N1092E-03

Information Only Service Note

N1092E DCA-M Sampling Oscilloscope

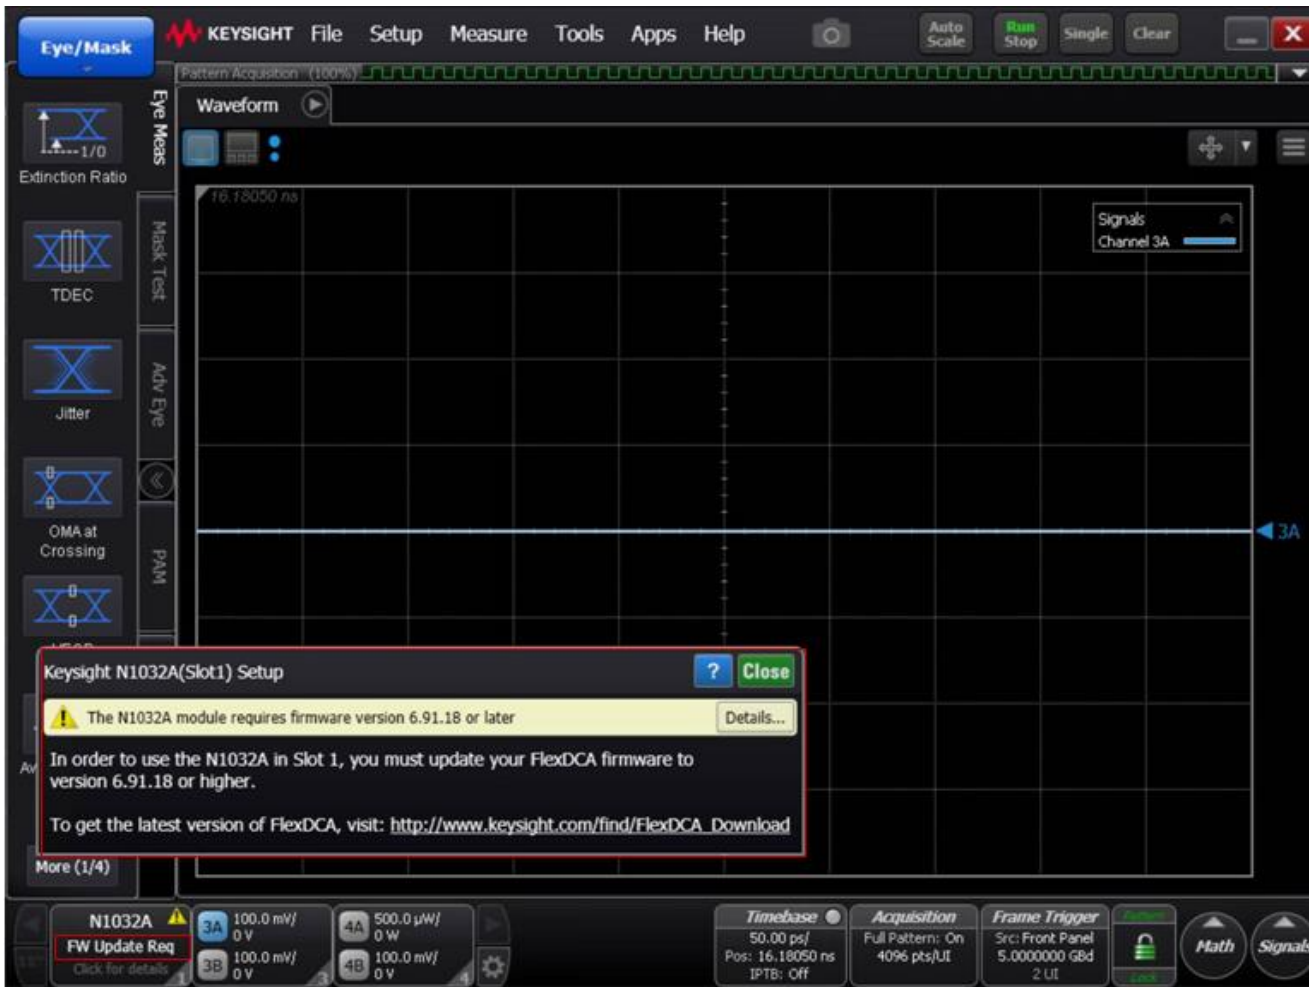
With the instrument connected to FlexDCA, if a message like the one below is displayed, FlexDCA must be updated to the indicated version (or later):

To update FlexDCA software, download from www.keysight.com/find/flexdca_download and install. While only the indicated version is required, updating to the latest version is recommended.
